SEWAGE DISPOSAL TESTING

MARYLAND STATE DEPARTMENT OF HEALTH

SUBDIVISION Plat Of Survey For Wilton M. Kiefer LOT NO. 1

PLAT OF SURVEY  
 FOR  
 WILTON M. KIEFER  
 FOURTH ELECTION DISTRICT OF HOWARD COUNTY, MARYLAND  
 SCALE: 1 IN. = 100 FT. JANUARY

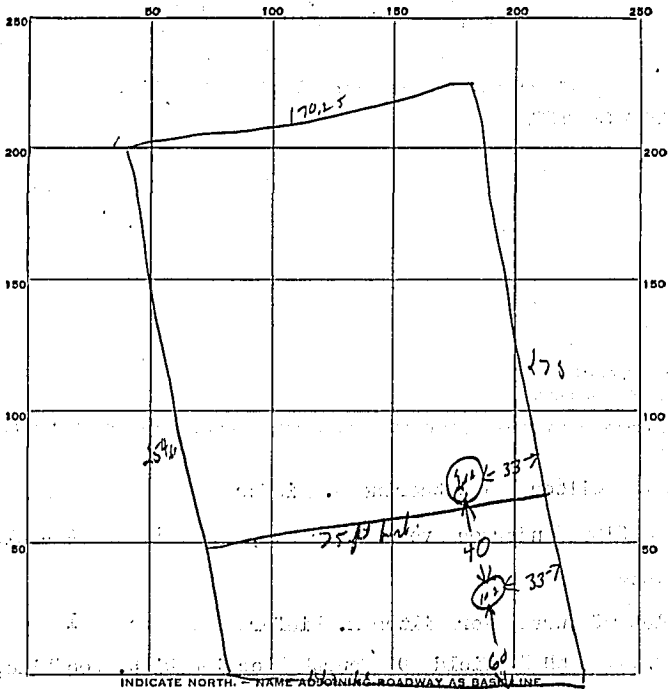
Dry Well - for 3 bedrooms - dig pit 16 ft. square - set block and top for 12 ft diameter and fill in rest of pit with gravel. fill pipe in deep pits to hand, below original grade.  
Dry Well to be 8 ft deep below inlet pipe!  
Dry Well - for 4 bedrooms - same as for 3 bedrooms except dry well to be 10 ft deep below inlet pipe

Place Dry Well about 100 ft from front lot line and about 75 ft from right side line and sewer when facing lot from Ed Warfield Rd.

APPROVED BY Donald W. McLaughlin FOR Dec. W. M. DATE 2-20-68  
(KIND OF SYSTEM)
